BLUE CHURCH ROAD UNDERPASS

PRELIMINARY - GENERAL PLAN

FOUNDATION INVESTIGATION REPORT

Subject: W.P. 25-59 Site #16-165
Blue Church Road Underpass
2.5 miles west of Prescott
Hwy. 401 - District 8

PRELIMINARY - GENERAL PLAN

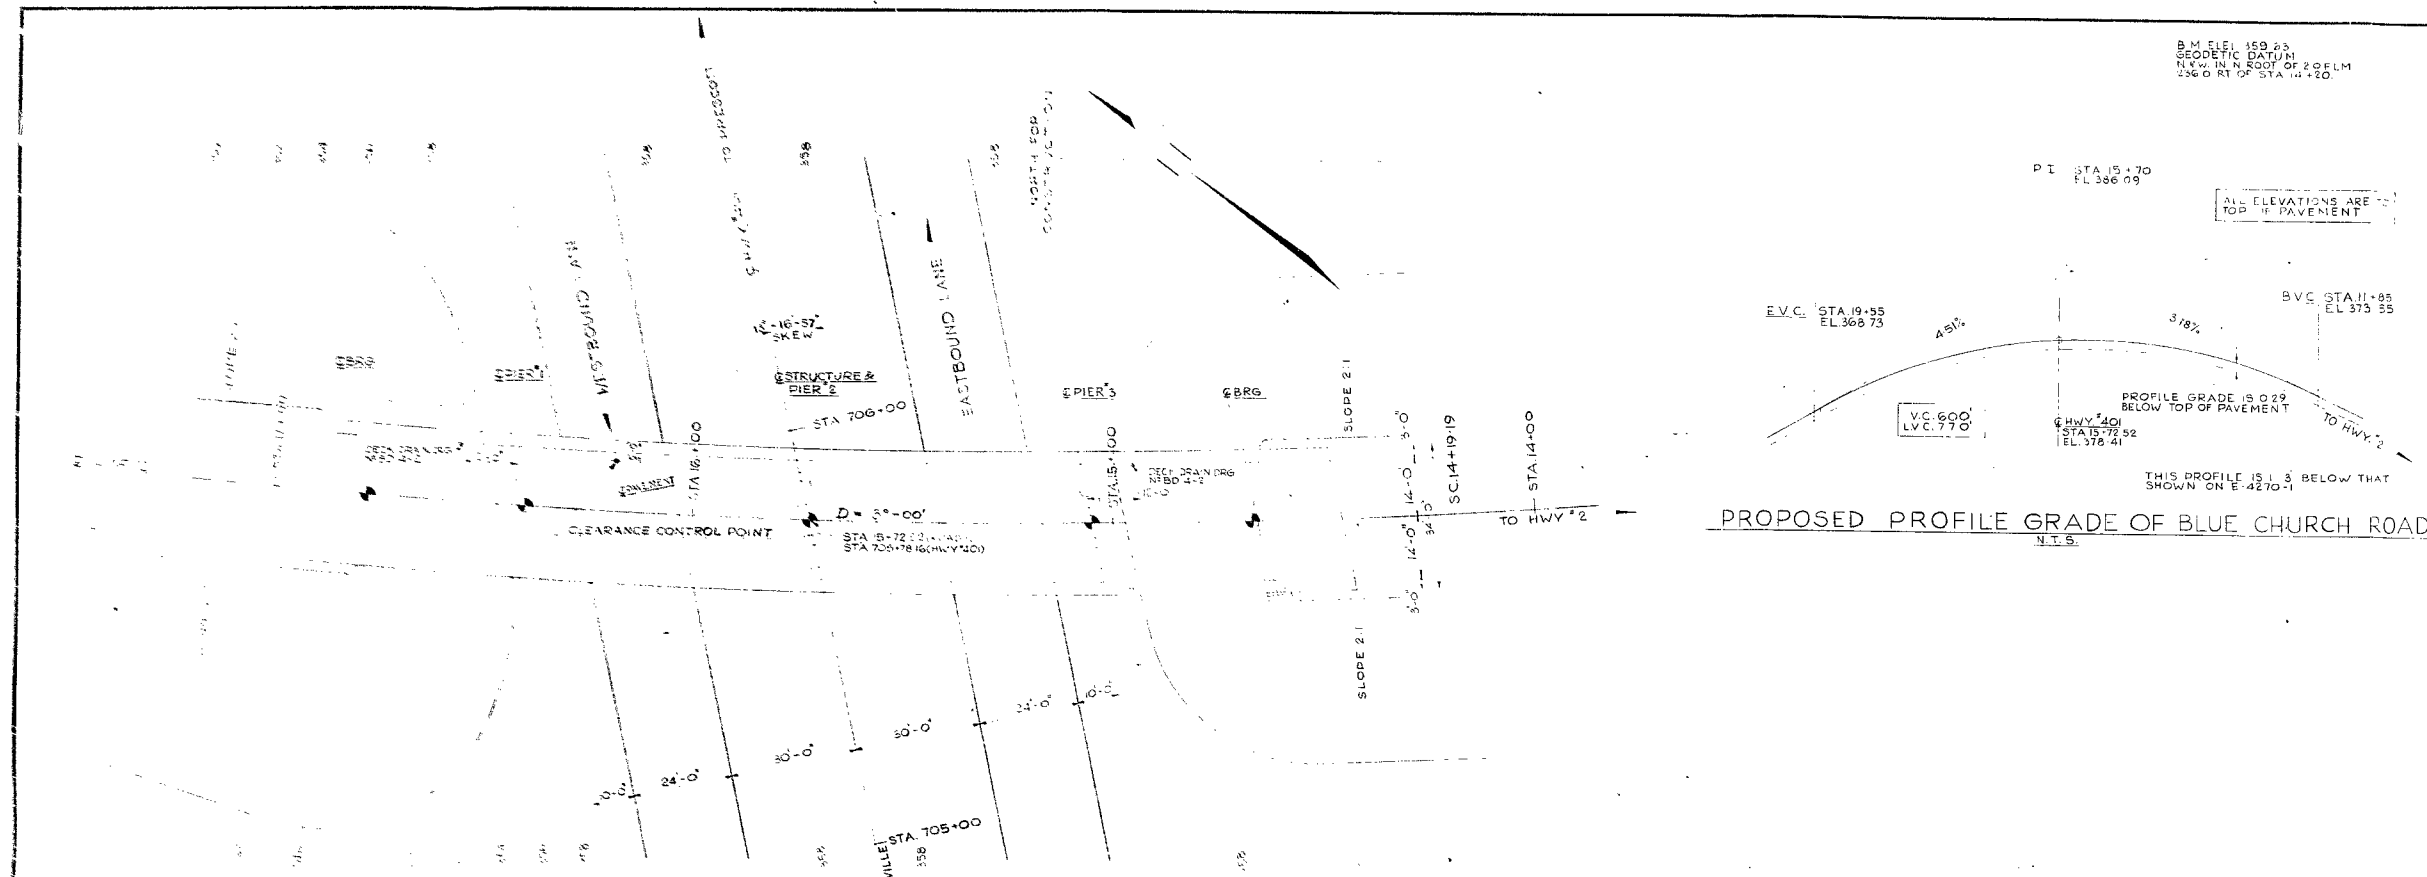
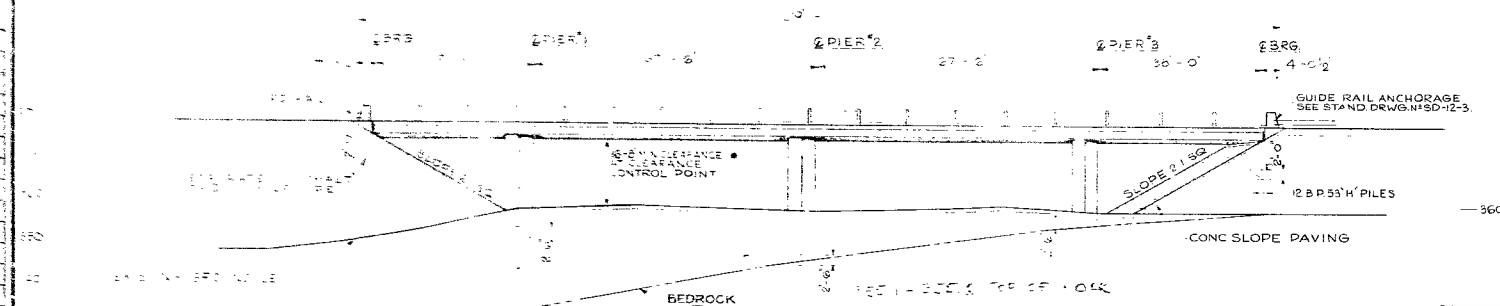
Would you kindly review the bridge foundations proposed and inform me if they are satisfactory.

No Comments Pler 1111 11/11/11

*Received A.P. Watt Dec 7th 64
No Comm - R.L.S.*
